Oak Bluffs Town Hall Flagpole Modification

Martha's Vineyard Commission

March 3, 2022

- To modify DRI 678-M decision to allow flagpole to remain in as-built location

Approved plan

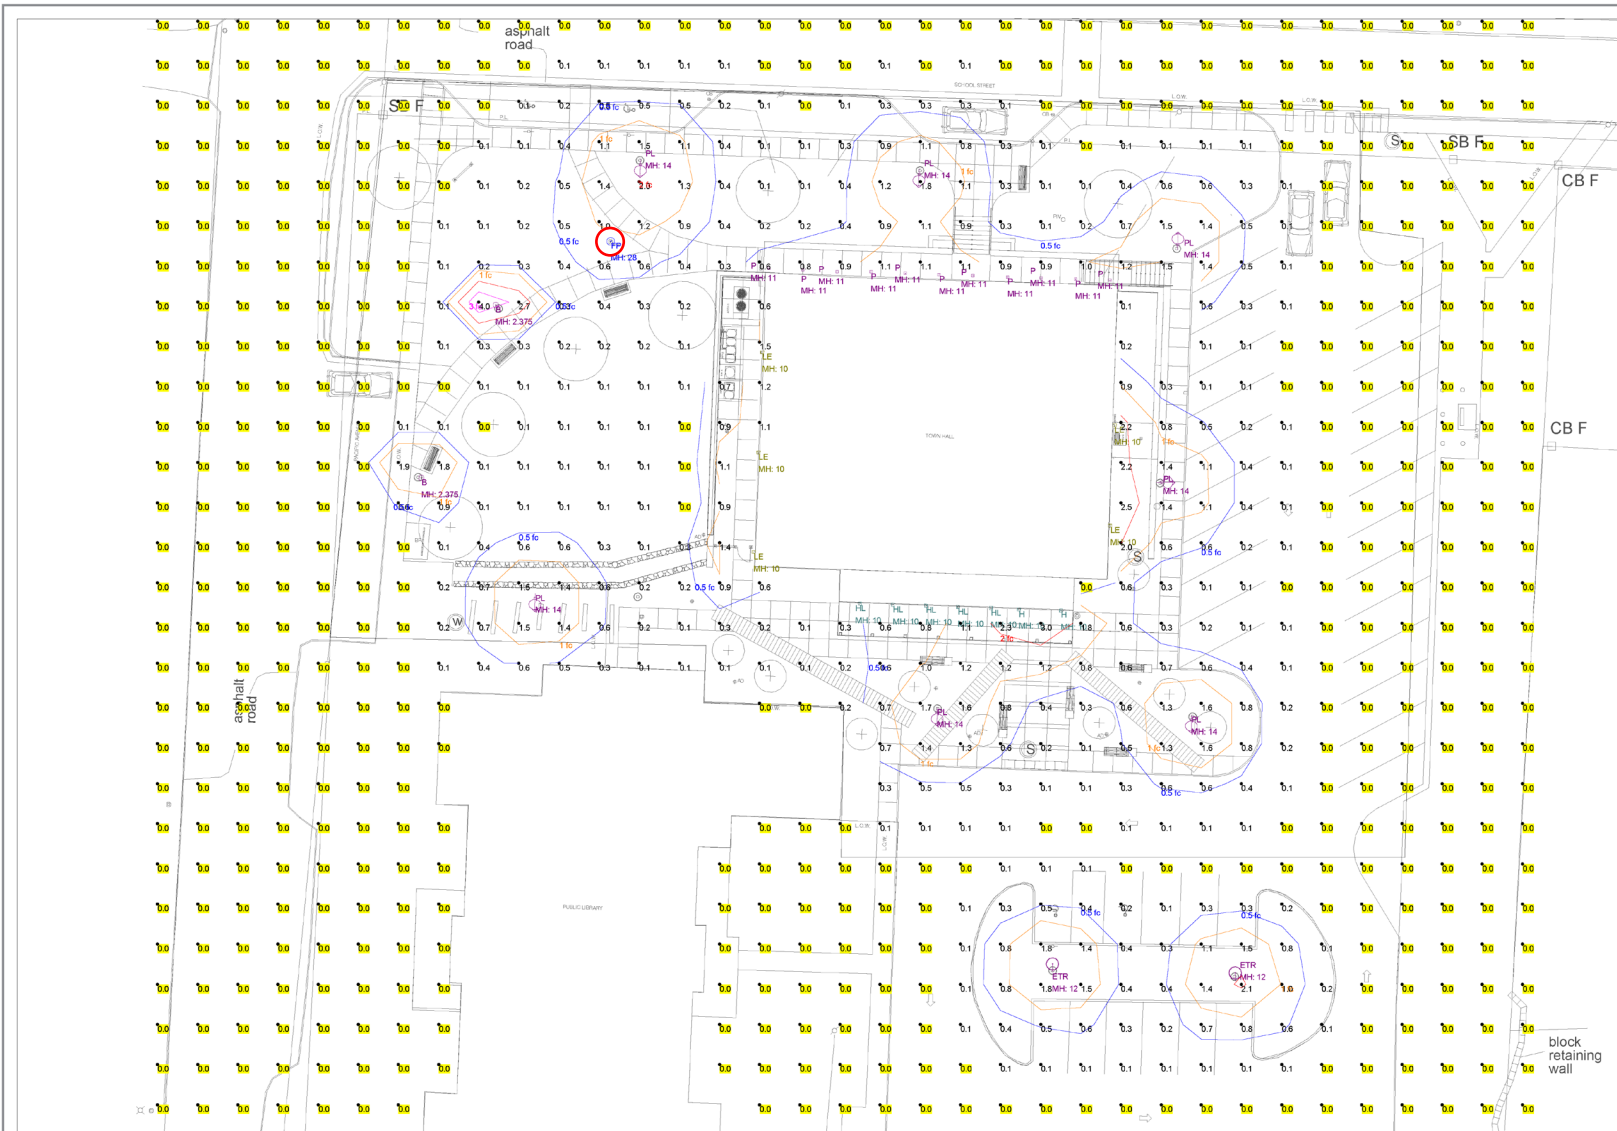
4. The poles at the curved walk should be replaced with bollards.
5. The flagpole should be moved north (to the other side of the curved walk) so as to minimize impact on green space. (Approved lighting plan showed correct location.)
